**ADDENDUM NUMBER:** FOUR (4)

**DATE:** February 20, 2026

**PROJECT:** LONE OAK COMMUNITY CENTER

**TO PLANHOLDERS:** This addendum is issued to modify the original Project Manual and Project Drawings, dated January 30, 2026 and is hereby made part of the contract documents. Acknowledge receipt of this Addendum in the space provided on the Bid Form. Failure to do so may subject the Bidder to disqualification.

# TO.1

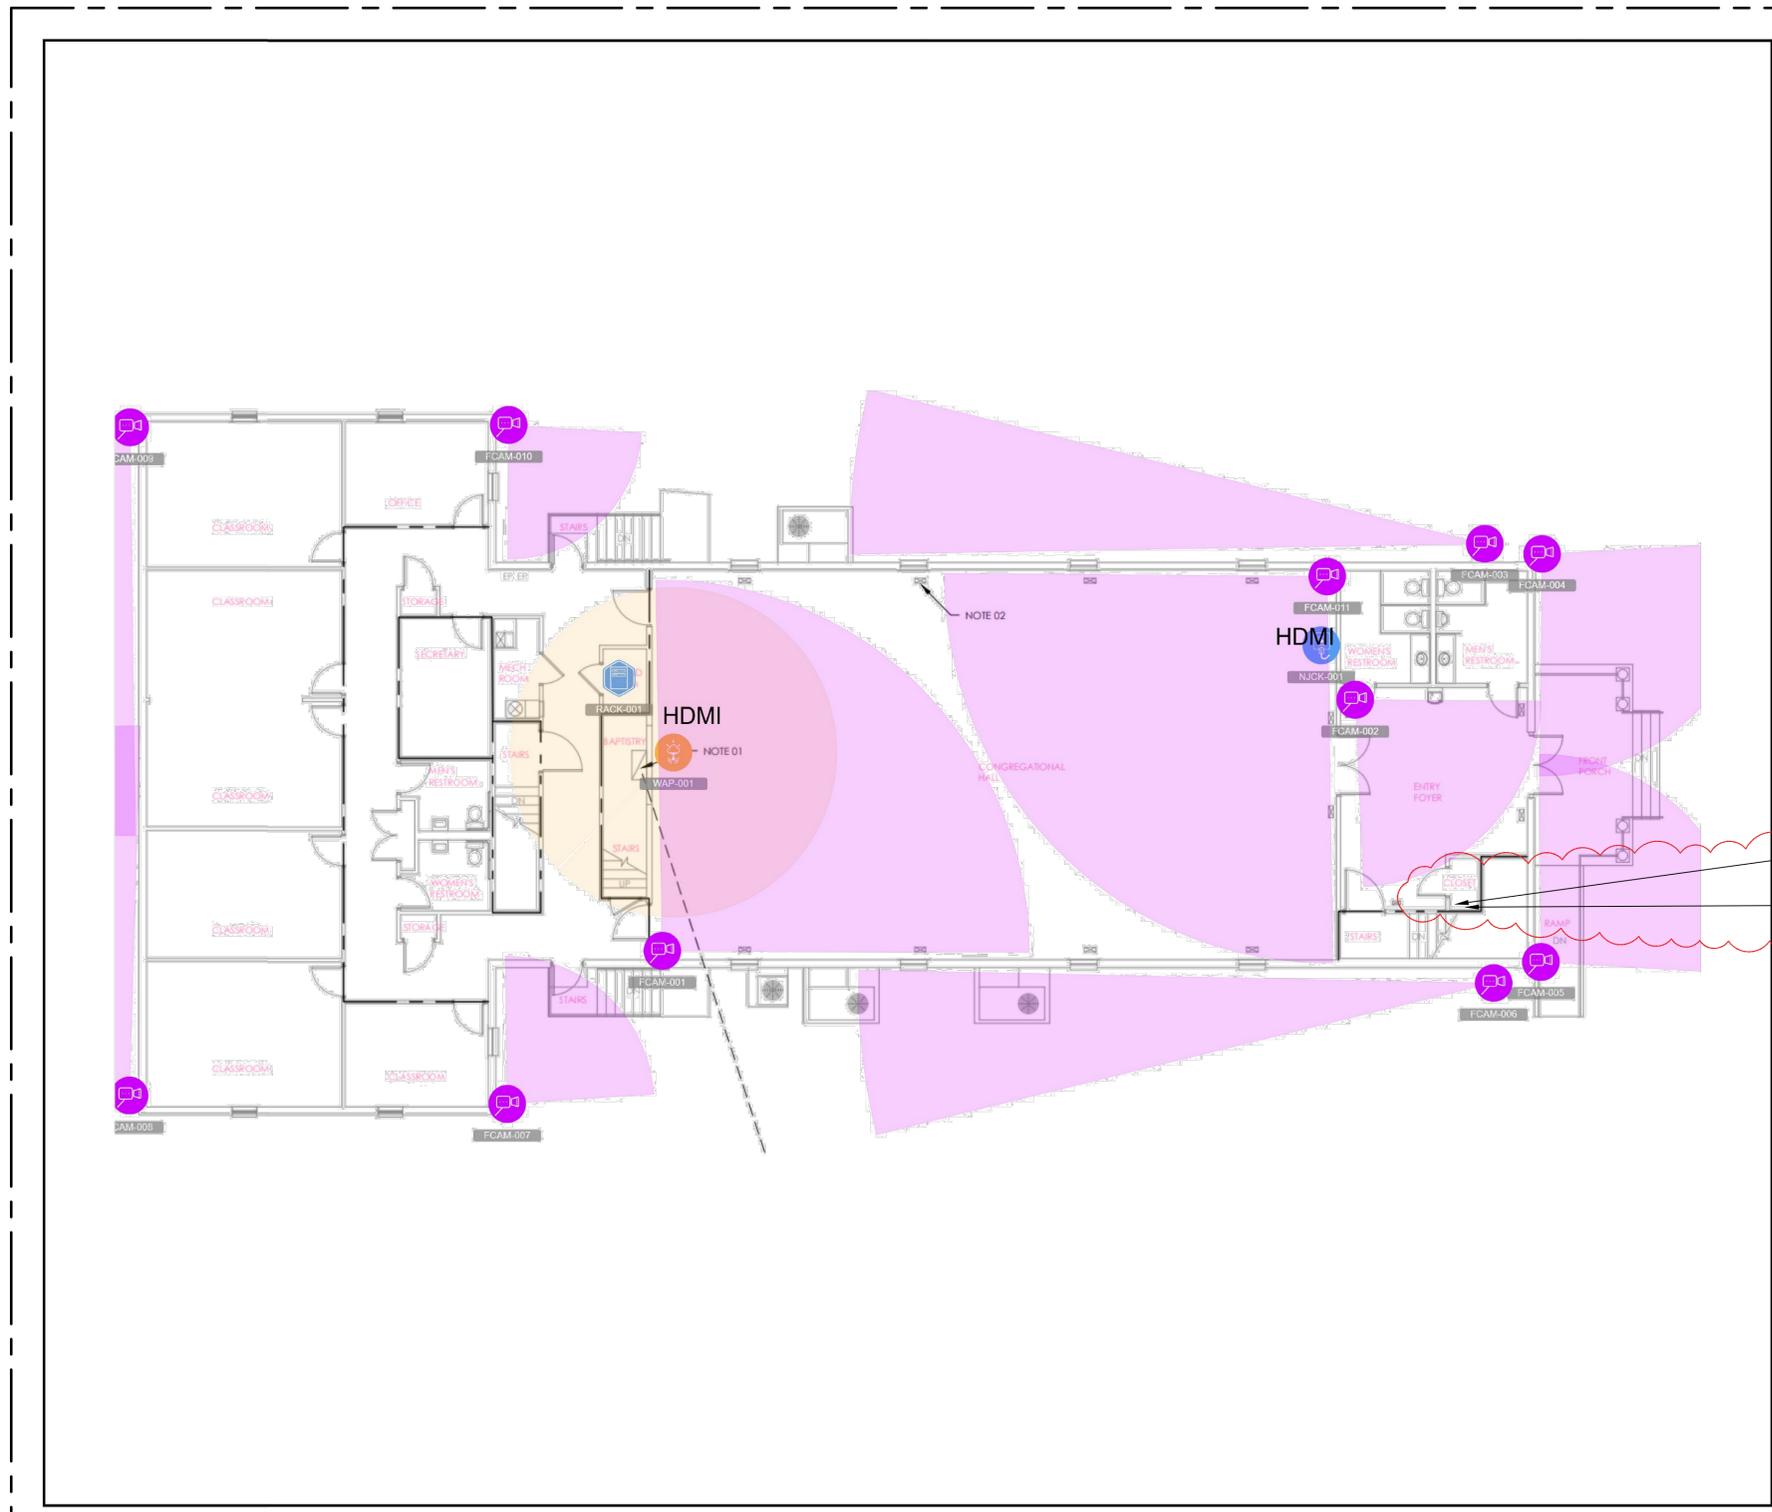
1. Sheet T0.1 Camera Technology delete sheet dated 02/13/2026 and replace with sheet dated 02/20/2026
  - a. Removed note on title block 'For Reference Only'
  - b. Added notes calling out installing conduit in new electrical chase

INSTALL 2" EMT CONDUIT FROM 6" ABOVE CEILING TO 4" BELOW FLOOR IN 5" x 8" CHASE

INSTALL 3" EMT CONDUIT FROM 6" ABOVE CEILING TO 4" BELOW FLOOR IN 5" x 8" CHASE
